PLANNING COMMISSION

Case No. P16-08

139 N. Court

Site Plan amendment

LANDSCAPE

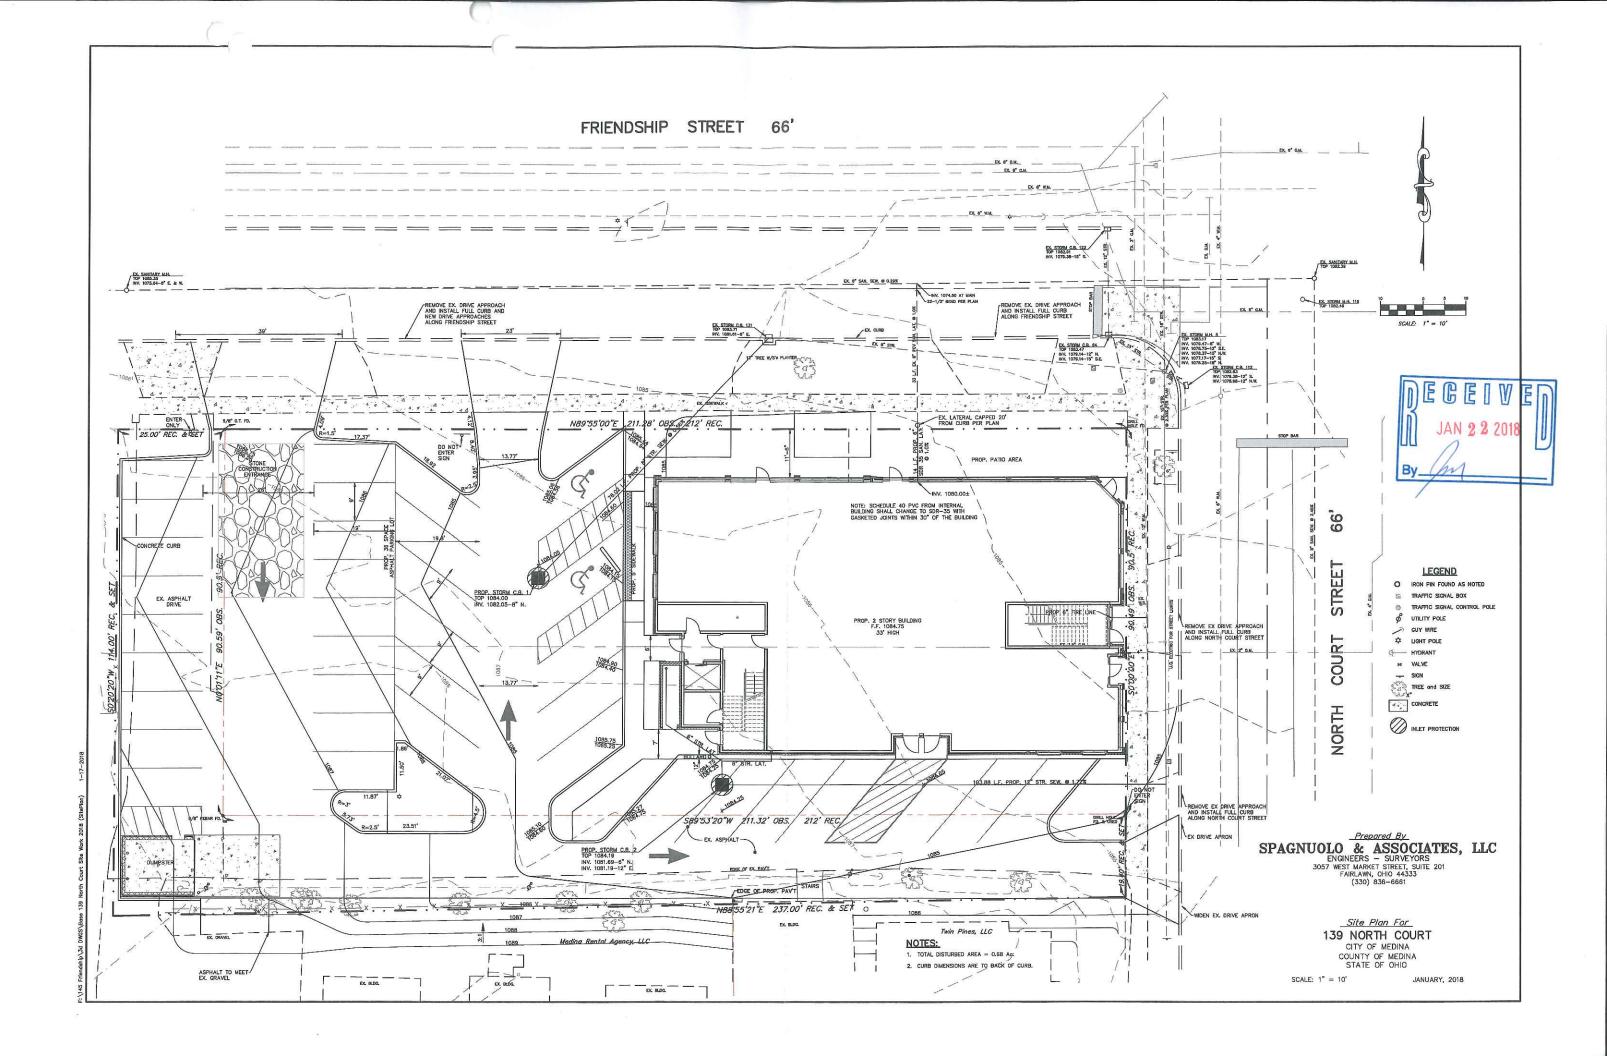
The proposed landscape plan nicely softens the edges of the building and parking lot along the W. Friendship St. and N. Court St. frontages and the transition areas to adjacent properties. This should help with the transition between the private and public realm for the non-building areas of the site.

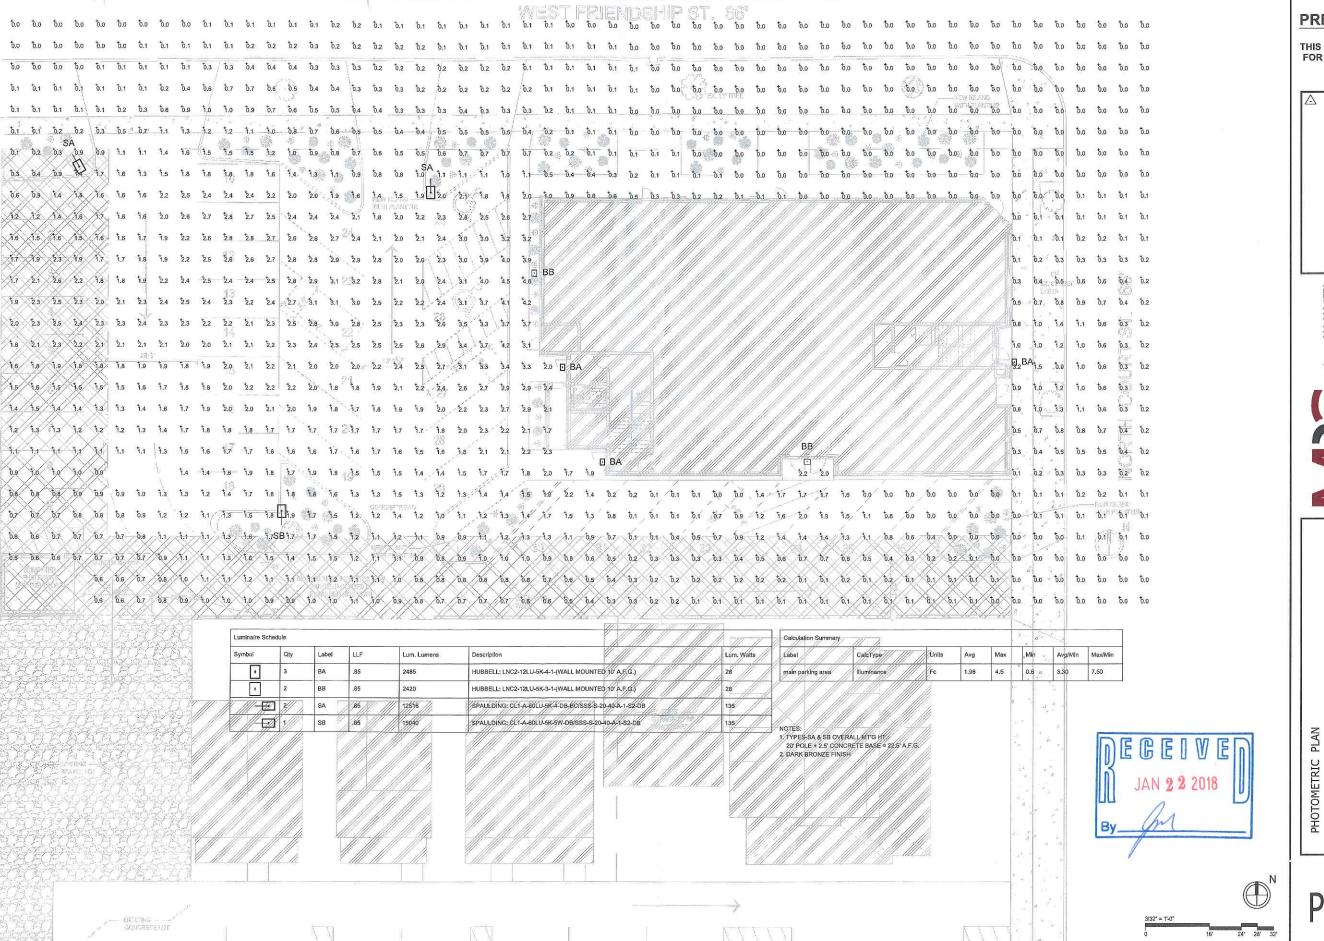
The current proposal has 36 space parking lot on the west and south sides of the expanded property to serve the building. Providing parking is solely at the applicant's discretion since Medina Codified Ordinance 26-78 established the downtown parking district which includes this property. The downtown parking district is exempt from the parking space requirements in Chapter 1145.

Although, parking is not required by the Planning and Zoning Code for this project, the parking area must meet the design requirements of the Code. The proposed parking area complies.

The applicant has provided a code compliant parking lot lighting plan.

1. Subject to review and approval of site development plans by the Medina Engineering Department to incorporate the expanded site improvements.
